D407-667-105TRN
Job Sheet 173570

Part Name: Crosstube Turning Detail

DRAWING NO. D407-667-145	TITLE CROSSTUBE ASS'Y (407 HIGH FWD)	REV. C	DART AEROSPACE LTD ENGINEERING ORDER		D.E.O. NO. D407-667-145-C-1	SHEET NO. SHEET 1 OF 1	SCALE NTS
DRAWN <i>Q</i>	CHECKED <i>ASS</i>	MFG. APPR. <i>IB</i>	APPROVED <i>MD</i>		DE APPR. <i>#</i>		
DATE 11.07.15	DATE 11.07.22	DATE 11.07.22	DATE 11/07/22		DATE 11.07.21

DRAWING NO. D407-667-145	TITLE CROSSTUBE ASS'Y (407 HIGH FWD)	REV. C	DART AEROSPACE LTD ENGINEERING ORDER	D.E.O. NO. D407-667-145-C-2	SHEET NO. SHEET 1 OF 1	SCALE NTS
DRAWN AJS	CHECKED <i>[Signature]</i>	MFG. APPR. <i>[Signature]</i>	APPROVED <i>[Signature]</i>	DE APPR. <i>[Signature]</i>		
DATE 12.08.02	DATE 12.08.02	DATE 12.08.02	DATE 12.08.02	DATE 12.08.02	DATE 12.08.02

DETAIL P
BONDING STRAP INSTALLATION 2 PL

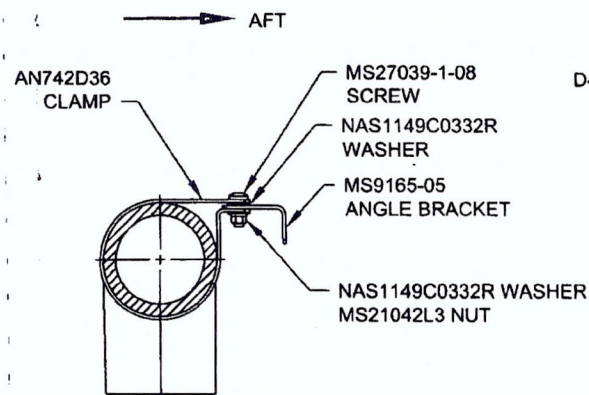
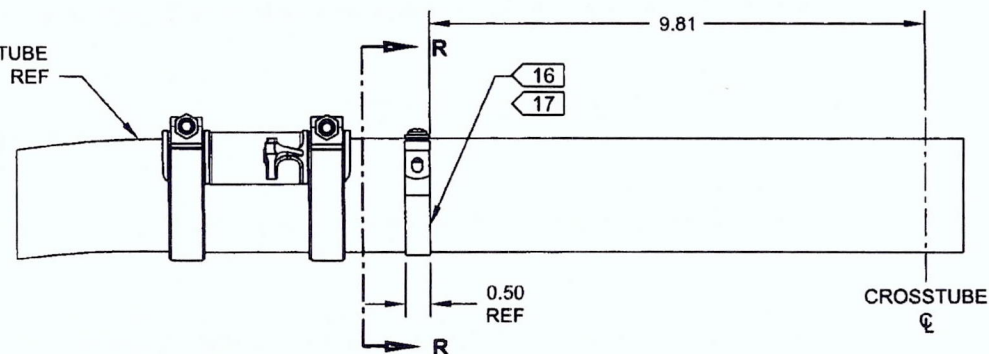
ADD ELECTRICAL GROUNDING STRAP

ITEM	QTY	PART NUMBER	DESCRIPTION
1	X	D407-667-145	CROSSTUBE ASSEMBLY (407 HIGH FWD)
10	2	AN742D36	CLAMP
11	2	MS9165-05	ANGLE BRACKET
12	2	MS21042L3	NUT (OR MS21042-3)
13	2	MS27039-1-08	SCREW
14	4	NAS1149C0332R	WASHER (OR AN960C10L)

- 16) MASK AREA UNDER CLAMP PRIOR TO PAINTING
- 17) SEAL EDGES WHERE AN742D36 CLAMP MEETS WITH THE CROSSTUBE USING SIKAFLEX-241/-291 OR MIL-S-8802 CLASS B2 OR PROSEAL 890 SEALANT
- 18) PERFORM RESISTANCE CHECK TO ENSURE MAX RESISTANCE IS 10 MILLIOHMS
